**City of Biddeford
Historic Preservation Commission**

RE: **Item 4.1: 2025.37 HPC Review** Archetype Architects to revise the design of a previously approved project at 6 and 14 Main Street, Tax Map 71, Lot 10/1 and Tax Map 71 Lot 10/4, respectively, in the MSRD-3 Zone.

Modification Request

Project:
BUILDINGS 19 & 20
PEPPERELL, BIDDEFORD, ME

Building 20 – SOUTH ELEVATION

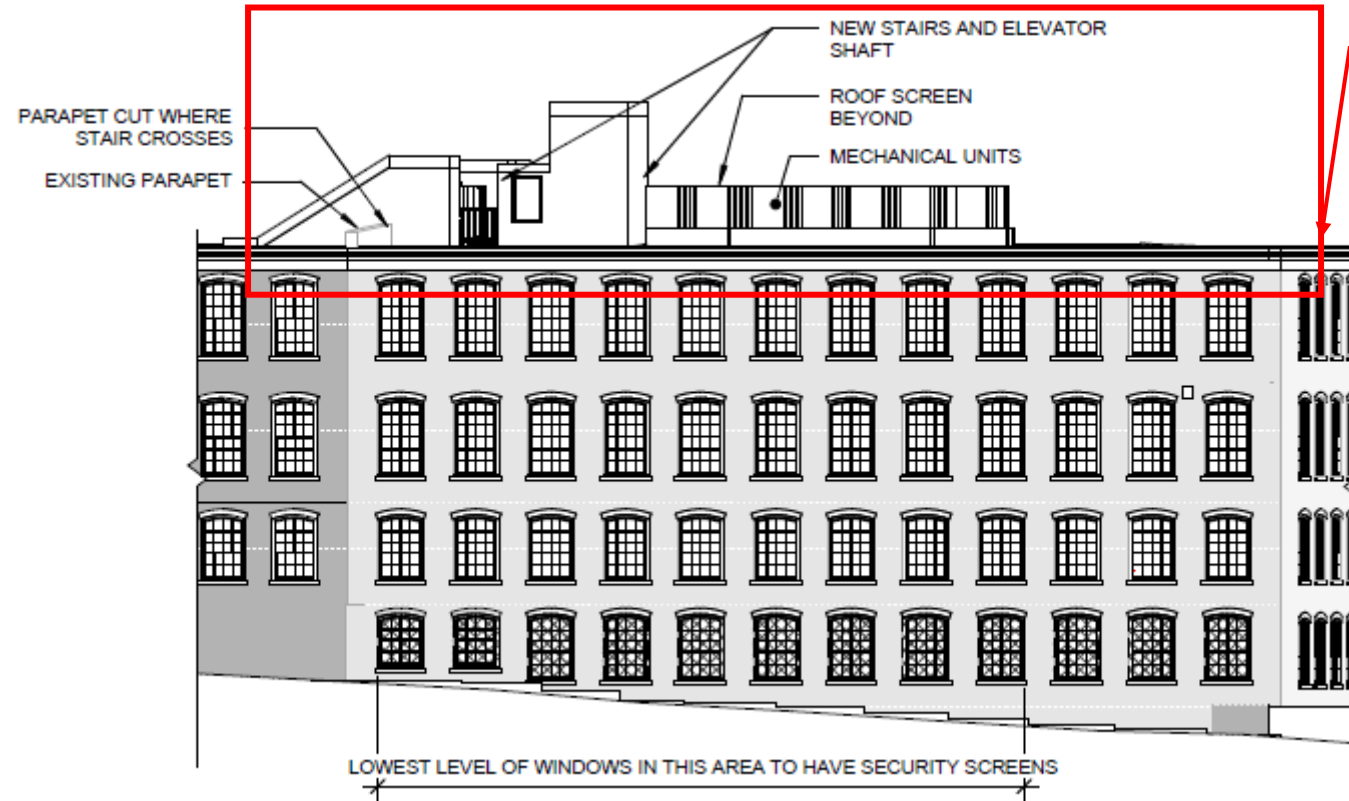
REMOVED ROOF ACCESS AND ROOF DECK

Building 19 & 20 – NORTH ELEVATION

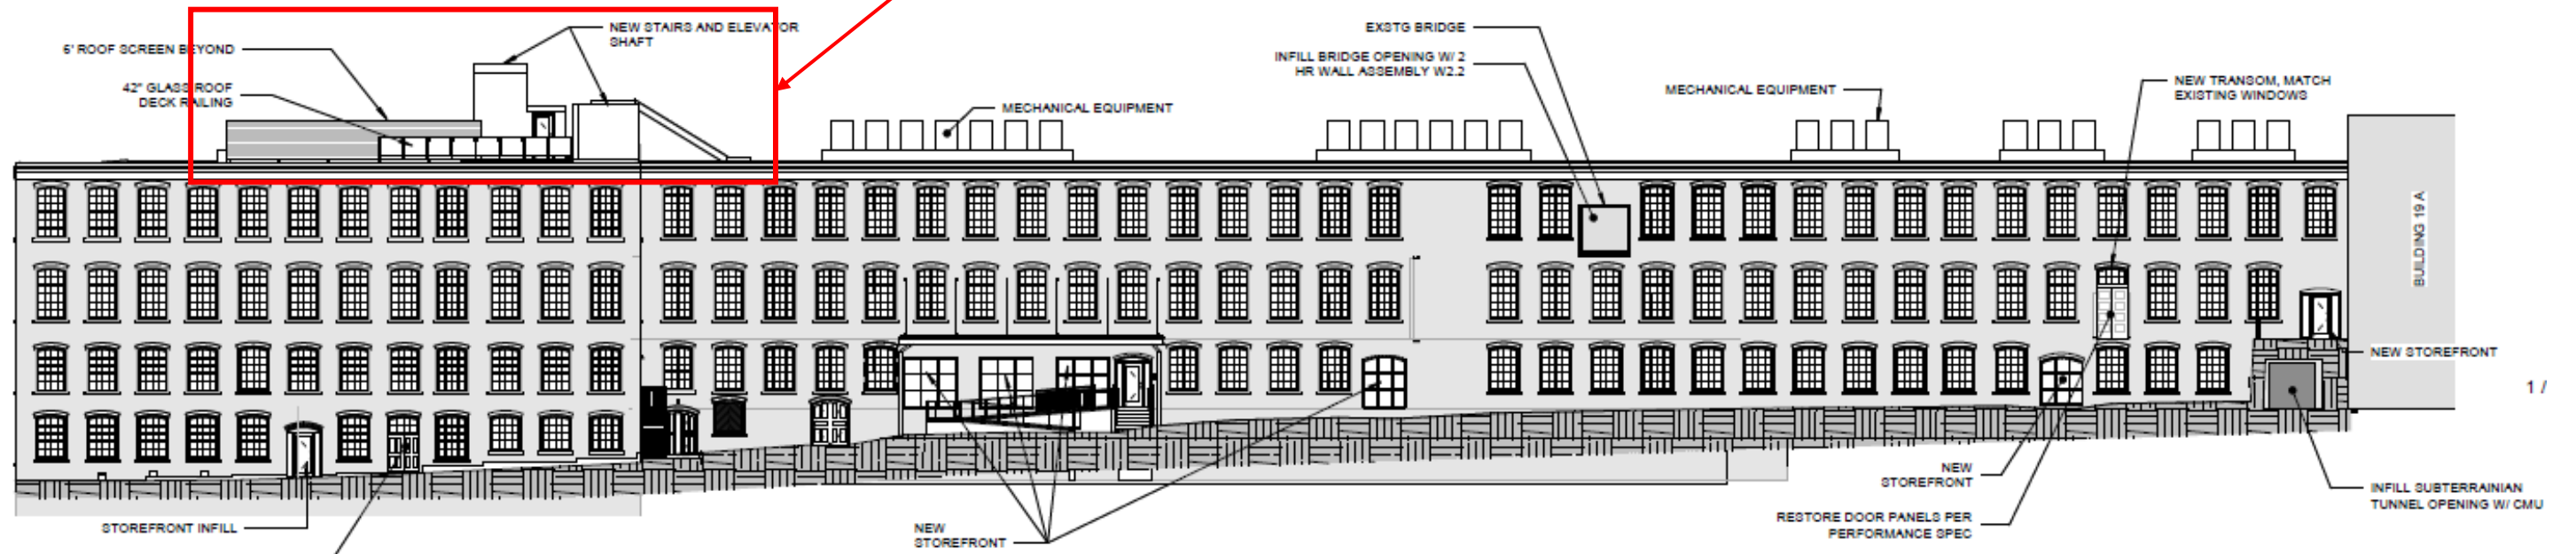
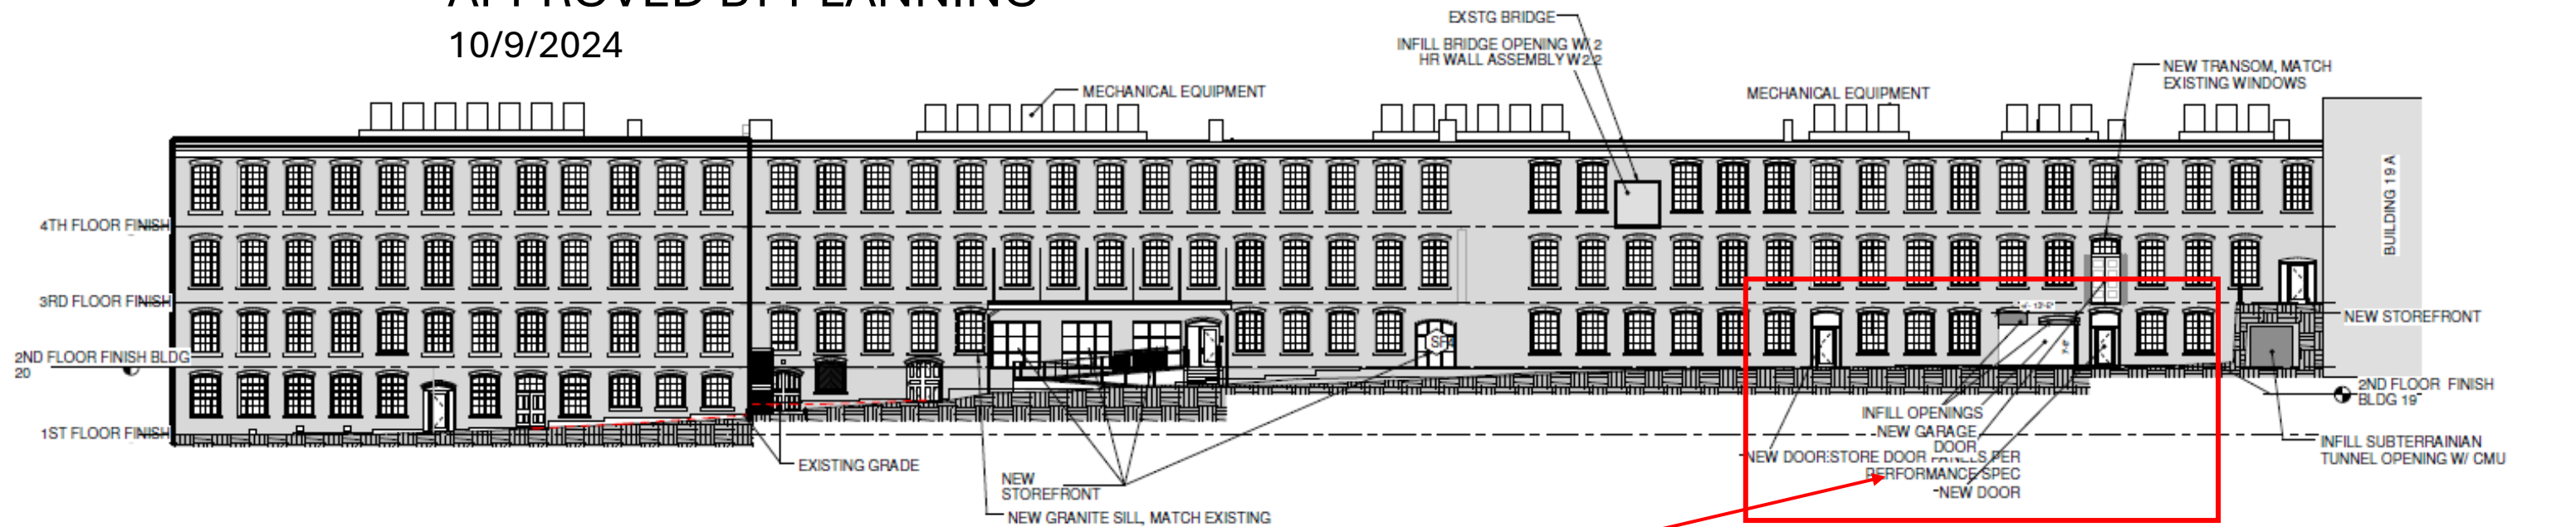
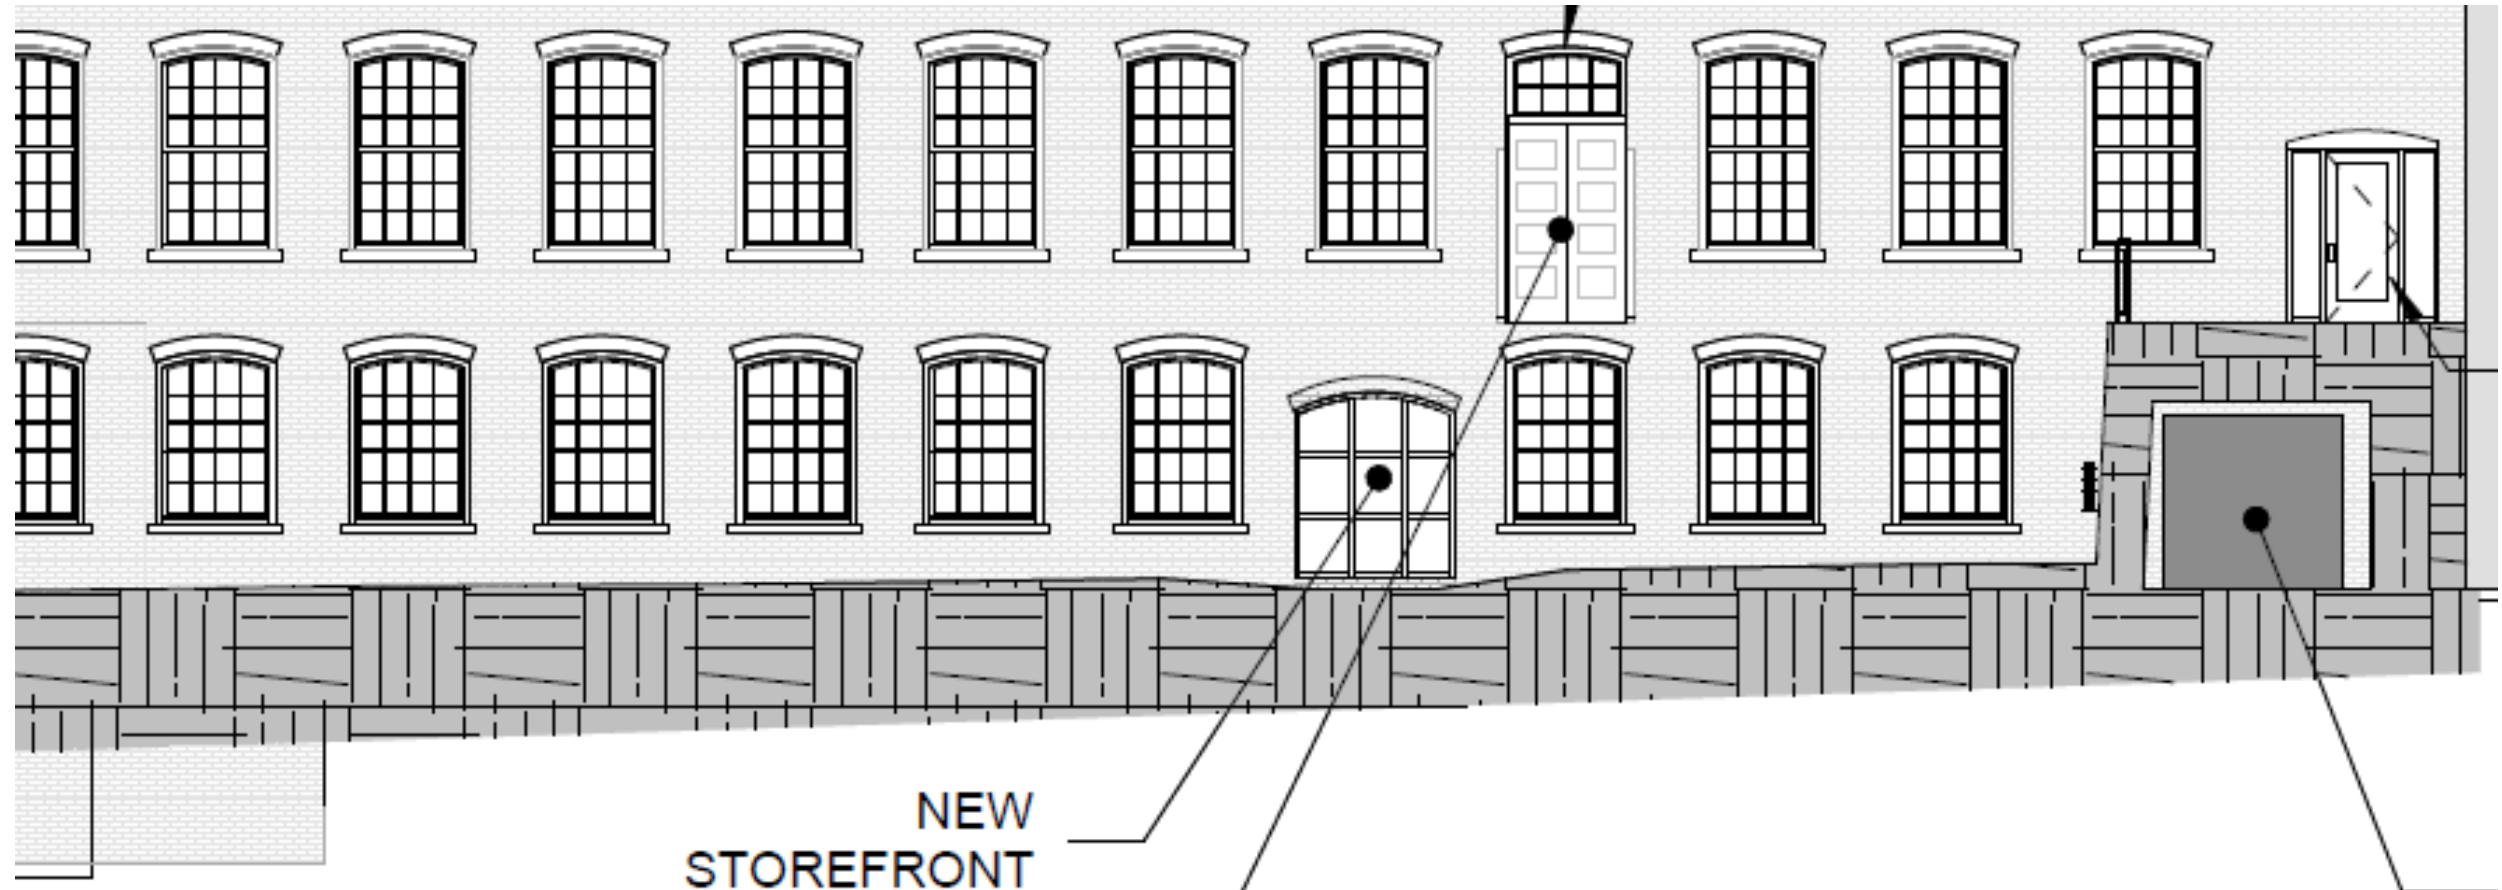
We propose adding 8 interior parking spaces on the 2nd floor between column lines 2 and 10. See attached 2nd floor plan Dwg. A1.03 dated 11/14/25. Modifications to the exterior involve adding egress doors at column lines 4/5 and 10/11. In addition, we propose enlarging the opening of 5/6 to include 6/7 which would allow for a garage door. See elevation sheet 2A2.01 dated 11/14/25.

REMOVED ROOF ACCESS
AND ROOF DECK

REVISED AREA
ADDED EXITS AND
GARAGE DOOR, SEE
PAGE 6

NEW
STOREFRONT

RESTORE DOOR PANELS PER
PERFORMANCE SPEC

Building 19 – SOUTH ELEVATION

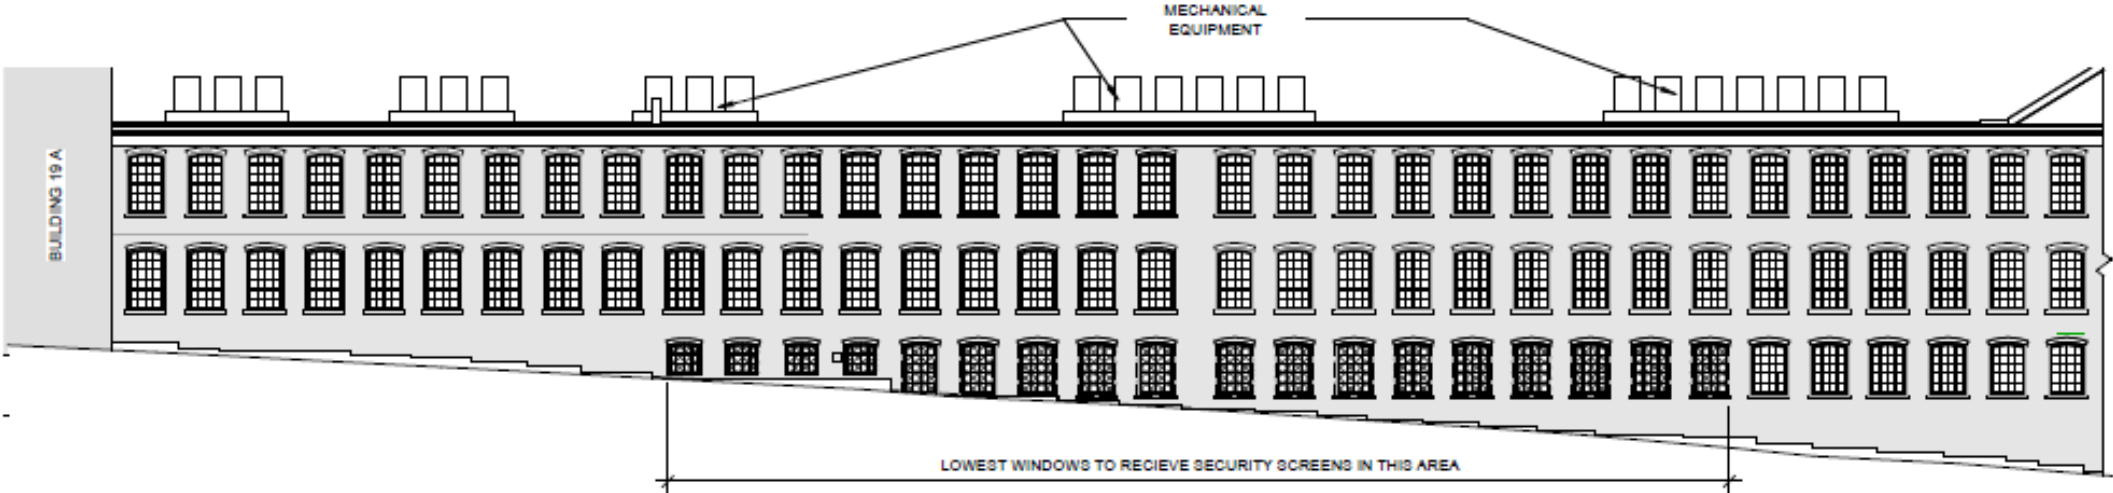
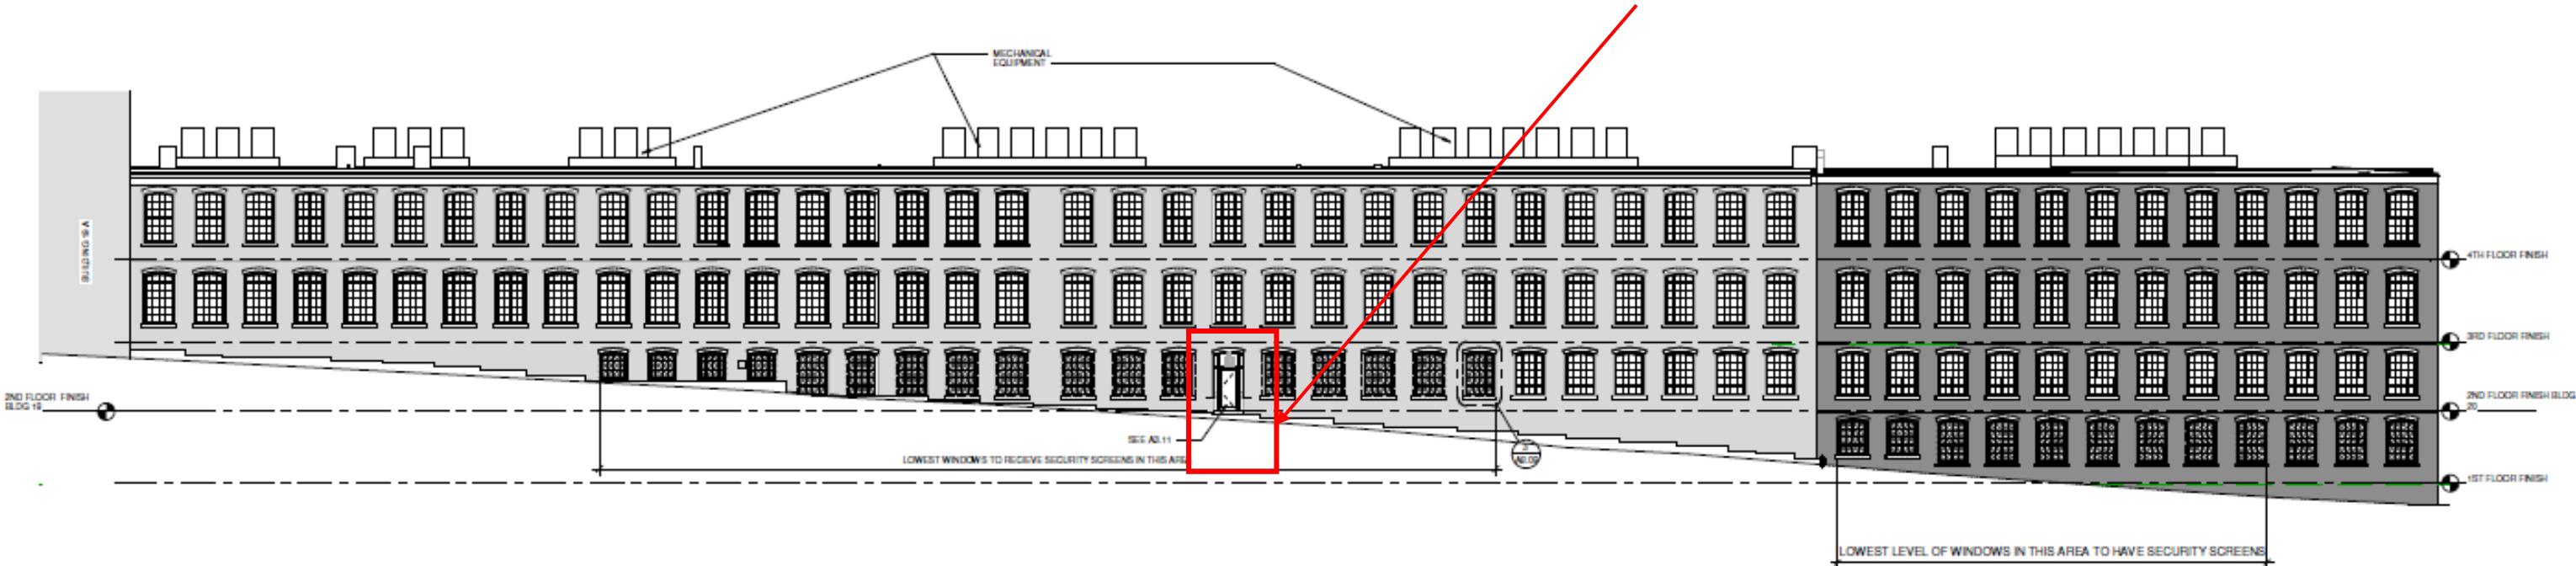
We propose adding a new entry of Main Street located in building 19 on the 2nd floor between column lines 20 and 21. The entry door will be recessed and will swing outward into a small entryway. There will be two risers and handrails. An exterior pendant light fixture will be installed in the recessed entryway. See Dwg A3.11 dated 11/14/2025.

PROPOSED ENTRY
